Dear Inspectors

At the 2 sessions on April 29 at the
Public enquiry the inspectors asked National
Grid to reply in writing to my husband
Andrew Buxton's talk. They have not yet
done this.

SAVILLS yellow C Macadam - N2T Proposed Alternative Route

Norwich to Tisbury
Figure: 7.12.F209_HE3a
Viewpoint HE3: Little Wenham Castle

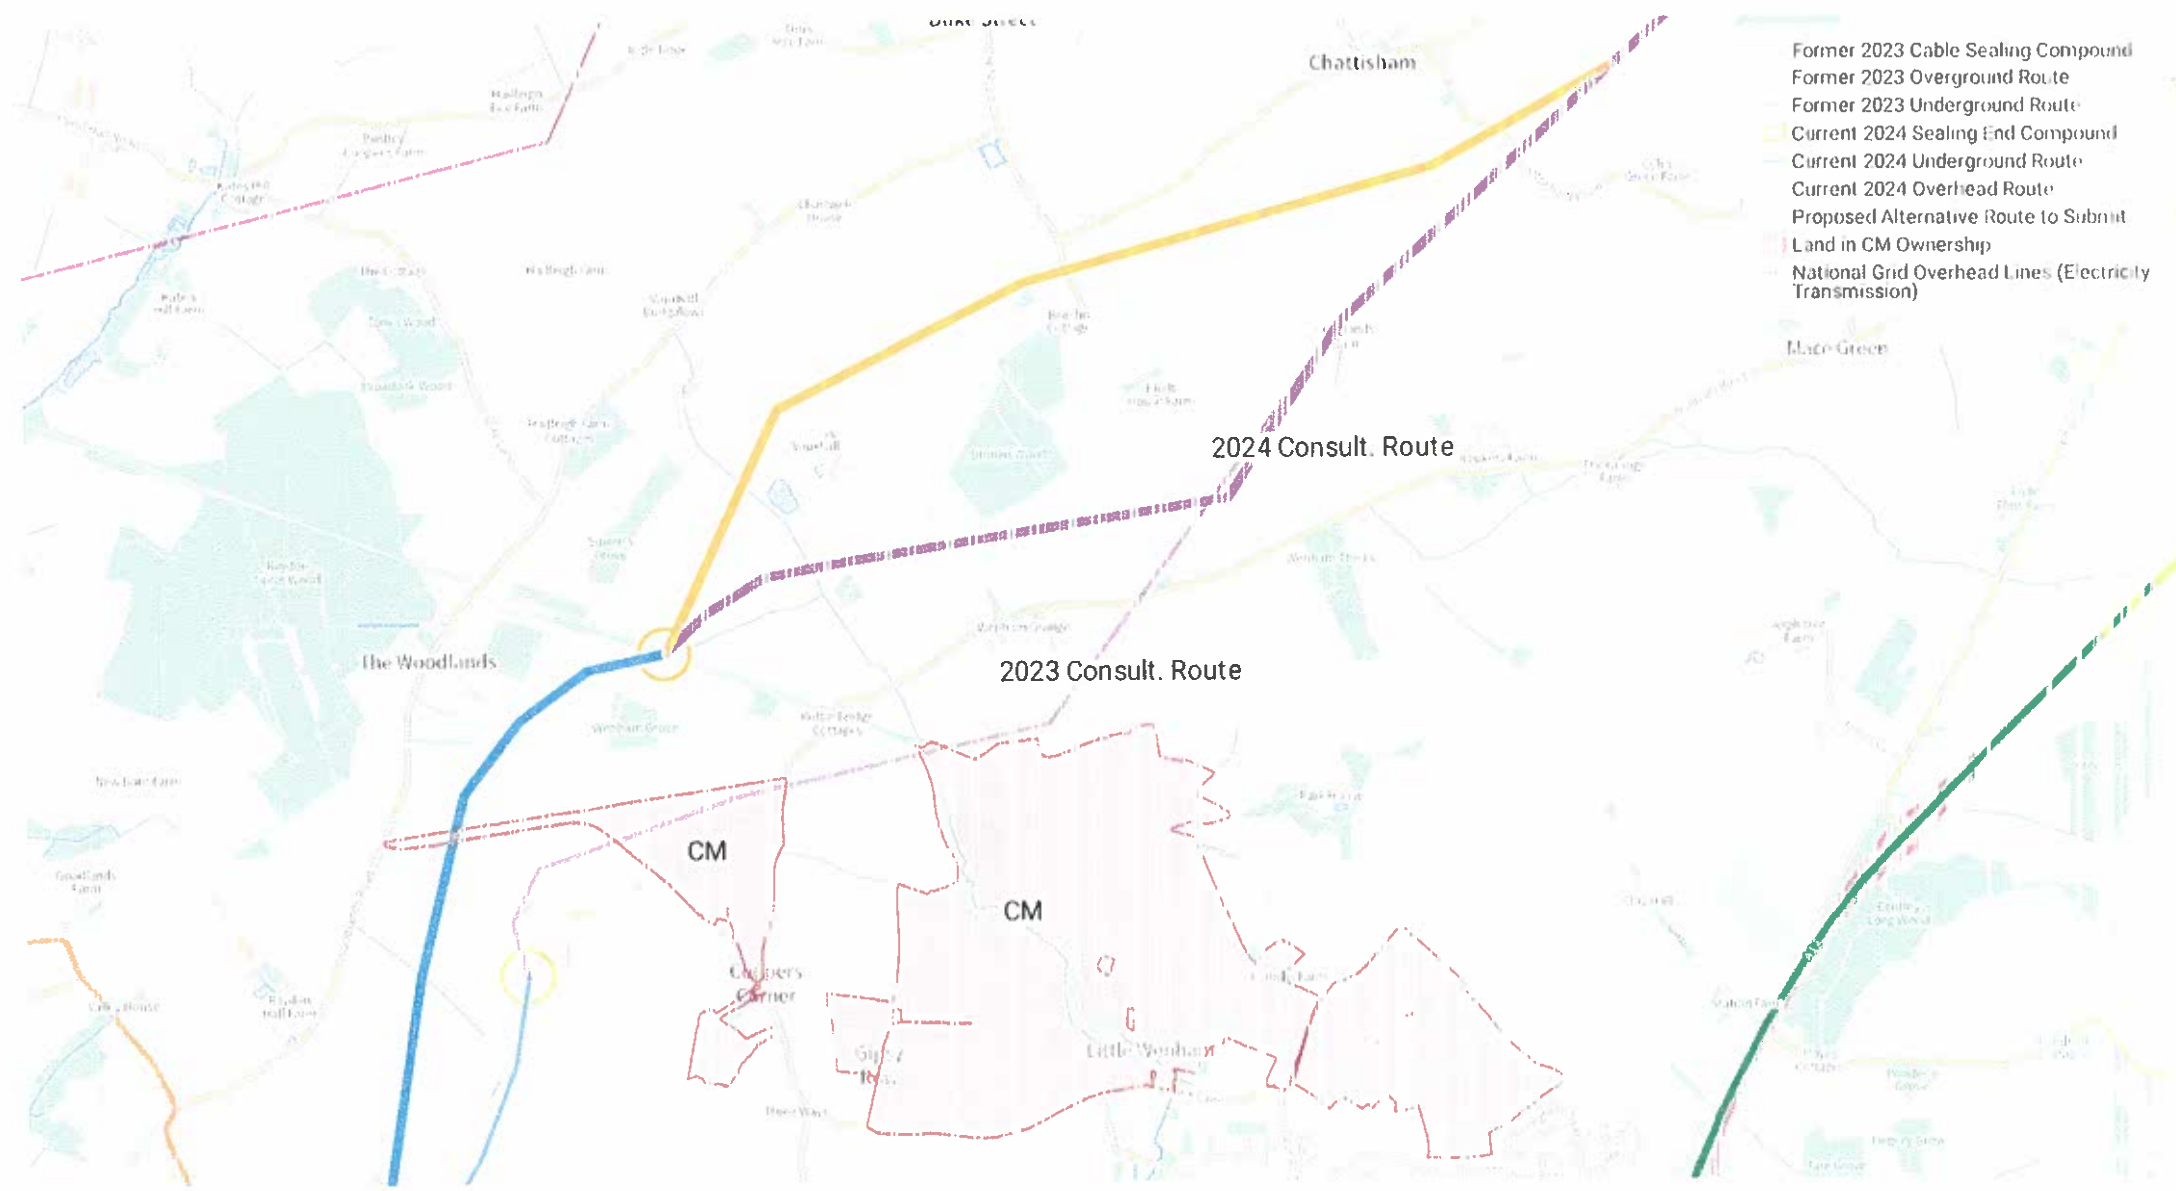
Choice of Route

Cable proposed.

Field difficult - drainage with this cable.

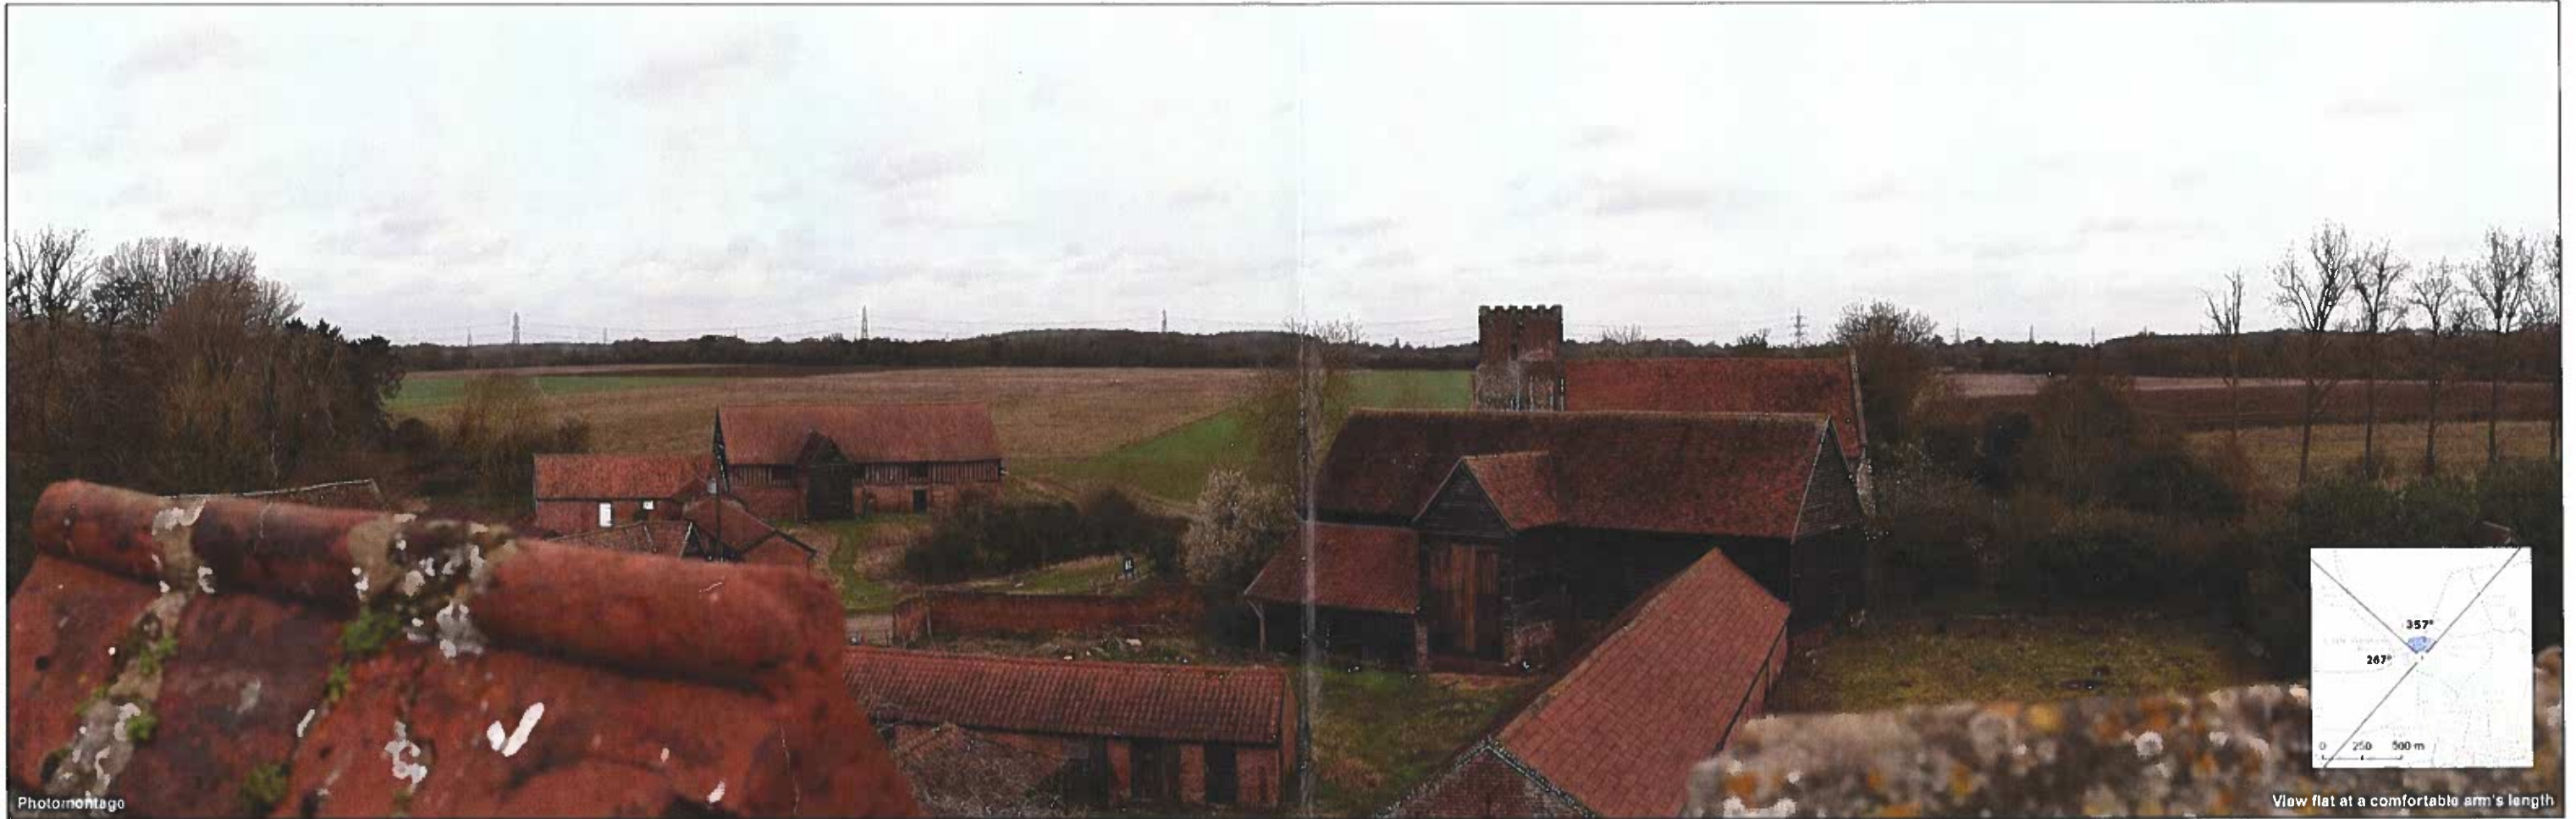
This is NOT Acceptable for a
Scheduled Monument.

A view of 9 pylons 1 km away.
on elevated land (2 metres higher)

Without trees you can easily see the CSE.
